TITLE: SPECIAL PERMIT NO. 04033, requested by Associated Engineering and Surveying on behalf of Sterling Hills, L.L.C., for 119 dwelling units and associated waiver requests, on property generally located northwest of the intersection of South 37th Street and Yankee Hill Road.

P.A.S.: Special Permit #04033 - Sterling Hills Community Unit Plan

GRADING PLAN
CUP AND SPECIAL PERMIT #04033
STERLING HILLS ADDITION
LINCOLN, NEBRASKA

To: Brian Will, Planning Department
From: Chad Blahak, Public Works and Utilities
Subject: Sterling Hills Preliminary Plat #04013
Date: June 7, 2004
cc: Randy Hoskins

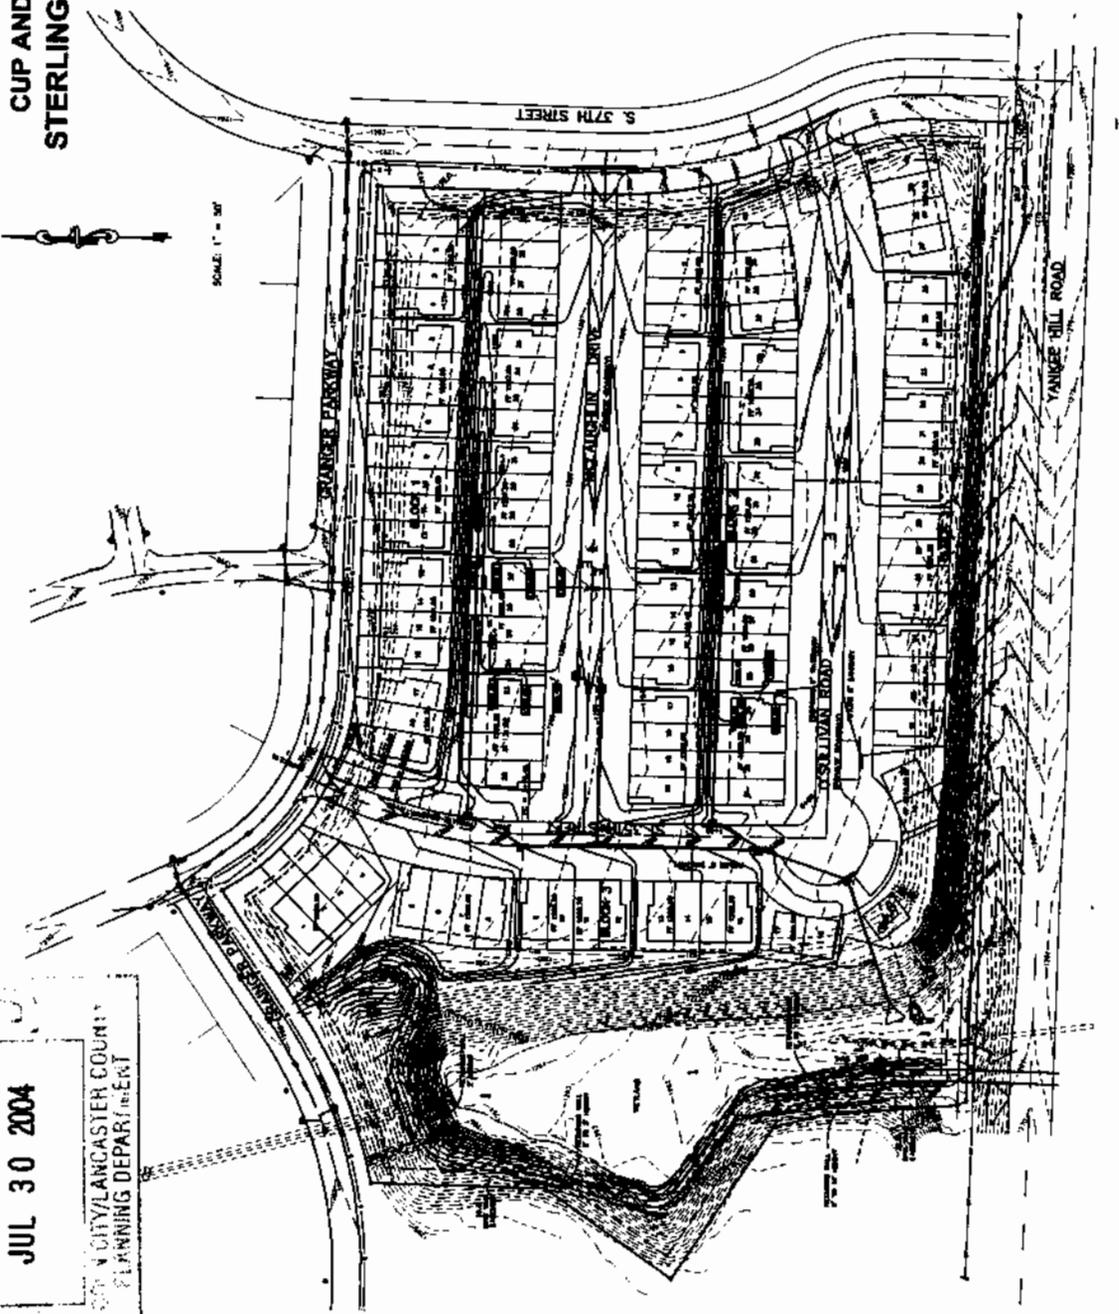
- (3.1) Lots 20-23 in Block 1 do not appear to provide sufficient drainage for the minimum opening elevations shown. The table on sheet 3 shows an elevation of 1285.90 for these lots while the grading plan shows an elevation of 1286.00 at the end of the block for drainage. The grading plan or minimum opening elevations will need to be revised accordingly.

- (3.2) Lots 21-28 in Block 2 do not appear to provide sufficient drainage for the minimum opening elevations shown. The table on sheet 3 shows an elevations between 1280.30 and 1180.59 for these lots while the grading plan shows an elevation of 1281.00 at the end of the block for drainage. The grading plan or minimum opening elevations will need to be revised accordingly.

- (3.3) Although there are no specific design standards for driveway slope, it should be noted that the proposed site grading and street grades shown appear to indicate driveway slopes of greater than 10%. As a comparison, maximum grade recommended by ADA is about 8.3%.

- (4.2) The proposed locations for the sidewalks shown in the interior of Blocks 1 and 2 do not appear to be realistic. The proposed grading plan shows the sidewalks being constructed along 3:1 slopes. This creates numerous practical issues. First, all lots on the up hill side of the sidewalk would require individual stairs for each lot, which are not shown on the plans. As a result of the need for stairs to connect to the sidewalk, there would be no satisfactory connection to the sidewalks that would meet ADA requirements. Second, the steep slopes would likely require retaining walls, which are also not shown, to be built in order to construct the sidewalks. Providing sidewalks adjacent to the streets rather than in the rear of the lots would eliminate these issues.

- 1.3 Revise the grading and drainage plan to the satisfaction of the Public Works and Utilities Department.
- 1.4 Enter into an agreement with the City for grading the site and constructing retaining walls and railings to accommodate the City's construction of the bike trail which acknowledges that the applicant's cost of construction is a contribution toward the
